HOWARD COUNTY HEALTH DEPARTMENT

RE: Building Permit Application B00116407
14180 Forsythe Road
Proposed Addition, Deck, Carport

RE: Building Permit Application B00116407
14180 Forsythe Road
Proposed Additional Bedroom, Deck, Carport

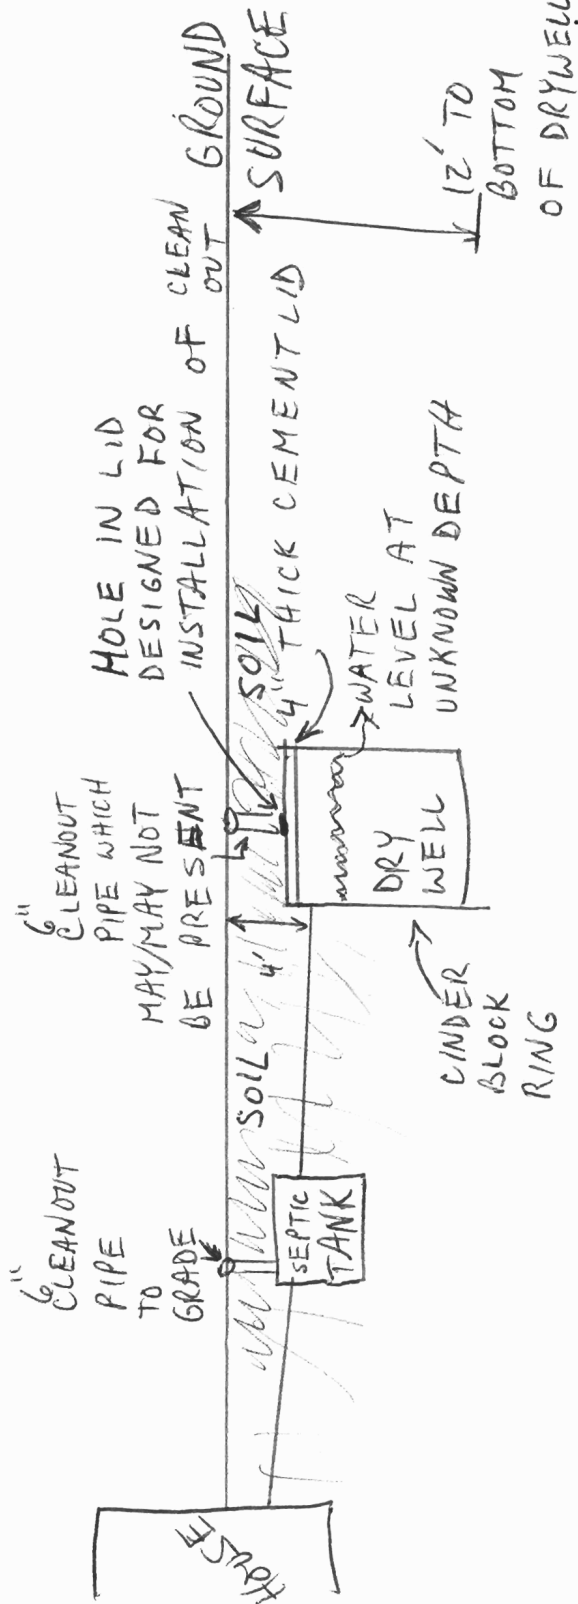
This is a followup to our conversation of this date. Attached is a schematic drawing of a standard septic tank-drywell layout. Standard drywell construction is as follows: At the center of a drywell is a ring structure built of cinder blocks or concrete rings. The pipe leaving the septic tank enters the drywell at a specified depth below grade (in this case 4 feet below grade, according to the property file). Just on top of the the pipe is a 4"-thick concrete lid. After the drywell and lid are installed, a cleanout pipe should be added and the site is backfilled with soil. Therefore, all parts of the drywell (other than any cleanout pipe) are covered with least 3.5 - 4 feet of soil.

Evaluation of the drywell would involve excavation to expose the top of the cleanout (if present) or the concrete lid, removal of a small 6" - 8" cap and evaluation of the drywell's remaining capacity based on measurement of the water level in the drywell. The total excavation is expected to be no deeper than 4 feet below grade. Unless the drywell is full or failing, at no time would sewage be expected to be exposed. If the drywell is full or failing, then a septic system repair (\$25 permit fee) would be expected.

A metal detector may help locate a cleanout. If none is available, a hand shovel may be useful. Use of a backhoe is the most certain option. This excavation can also be completed during the early stages of construction.

4/12/99+ T/C W/OWNER-EVENTUALLY
AGREED TO ~~ACCEPT~~ ^{APPROVE} ~~W/~~ CONTINGENT
ON WRITTEN COMMITMENT TO EVAL.
S.S. W/IN 6 MOS. & PAYMENT OF
MR \$25 REPAIR
cc: File MR
